NUMBER: 23-008-03

SUBJECT:

Right Side Cowl Water Leak

This bulletin involves sealing a right side cowl seam.

Fig. 1 RIGHT SIDE COWL BODY SEAMS

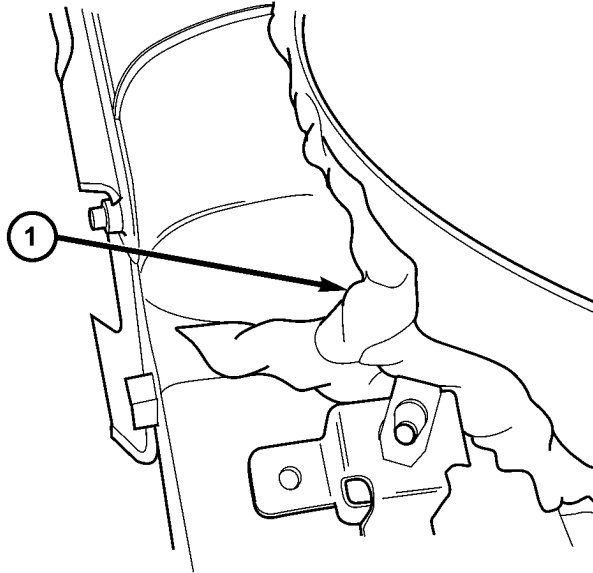
1. Open Hood.
2. Remove the three screws holding the cowl grille/screen on the passenger side of the vehicle.
3. Partially remove hood to cowl seal, at the leading edge of cowl grille/screen.
4. Disengage grille/cowl screen anchor at center of cowl.
5. Rotate the right side cowl grille/screen out of the way of the cowl plenum being careful to not pull cowl grille/screen upper weatherstrip off.
6. Locate the large vertical and horizontal sealer beads near the right outboard cowl grille screen mounting screw attaching point (Fig. 1). The sealer beads are at the junction of the A-pillar, cowl plenum upper and cowl side panel. Apply Mopar Silicone Windshield & Glass Sealer, p/n 04467708, to the outer edge of all existing sealer beads.

1 - APPLY SEALER

- 7. Allow sealer to set up for 30 minutes. Water test right lower cowl area to verify repair. install passenger side cowl trim.
- 8. Reverse above procedure to install the cowl grille/screen.
